# Engineering Consideration

Leonardslee Lakes & Gardens

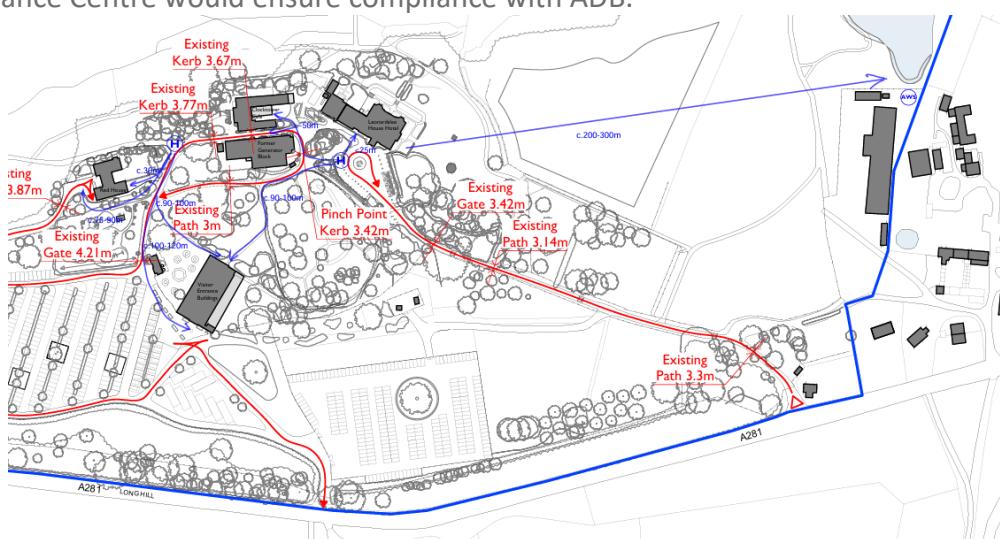
Two private fire hydrants are provided within the Leonardslee Estate. One is located between the Red House, Clocktower Café and Former Generator Block, and the second is positioned within the car park in front of Leonardslee House Hotel. These are likely historical installations, compensating for the lack of suitably located statutory hydrants on the A281.

Approved Document B (ADB) recommends that private hydrants should be located within 90 m of the entry point to the building they serve. Using the *Proposed Site Plan* (1:2500 scale), approximate distance checks have been carried out. Several buildings—including Red House, Clocktower Café, Former Generator Block and Leonardslee House Hotel—fall within this range.

However, the Visitor Entrance Building is located beyond 90 m from either private hydrant. Likely appliance positioning at the front of the building would result in hose runs of approximately 100–120 m, exceeding the preferred ADB distance. Operationally, this is still manageable through the deployment of up to five lengths of 70 mm hose, but it requires additional time and resources. The building remains capable of being supplied from either hydrant, but the gradient difference between both private hydrants to the Visitor Entrance Centre will require greater pump pressure to provide water supply. Therefore, it is important that the private hydrants are maintained correctly to ensure full pressure and flow if required. An additional private hydrant located to the west of the Visitor Entrance Centre would ensure compliance with ADB.

*Note - An additional private hydrant constructed to the west of the Visitor Entrance Building would provide additional resilience and negate the requirement for longer hose runs, should a fire occur at the Visitor Entrance Building. Although not considered a requirement for this development, the RP may wish to consider providing additional private hydrants when opportune to do so.*

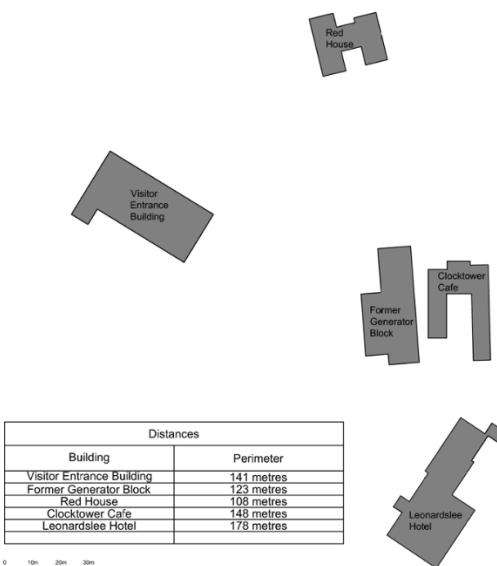
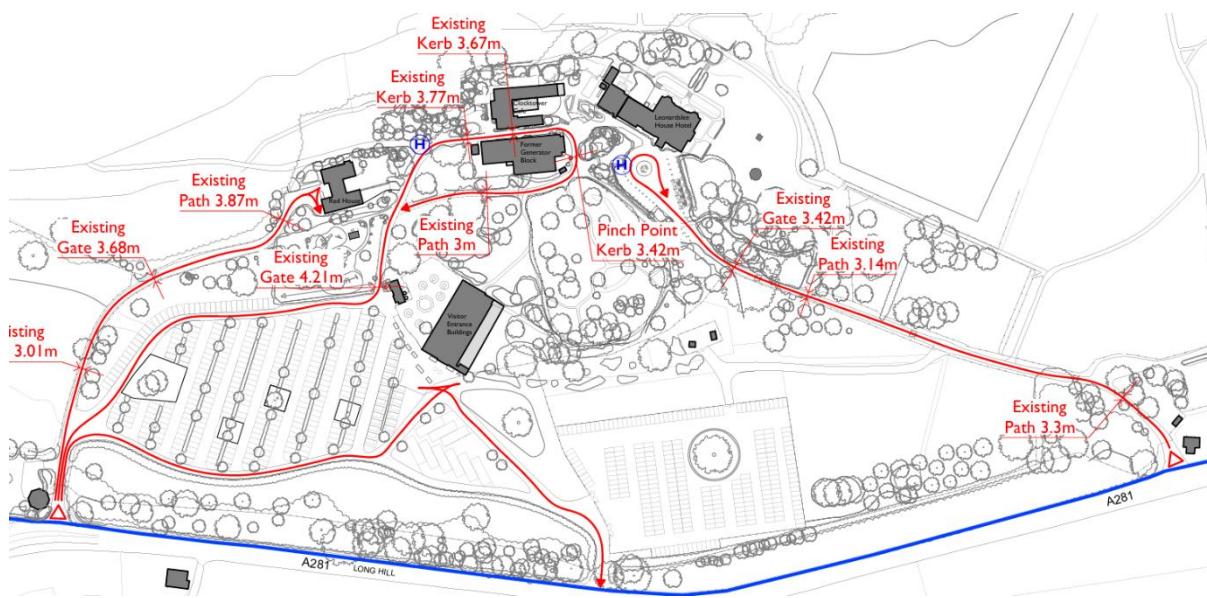
We have been provided with drawings (242769-PUR-01-00-DR-A-6001, 242769-PUR-05-00-DR-A-6001 and 242769-PUR-08-00-DR-A-6001) detailing hose routes around the properties, given the layouts it is considered that all areas are able to be reached within 45m of the fire appliance. Additionally, a perimeter calculation has been carried out for each building on the estate, which demonstrates that 15% accessibility is achievable. Both tests for access are therefore achievable and this is considered to demonstrate compliance with Requirement B5 of the Building Regulations.
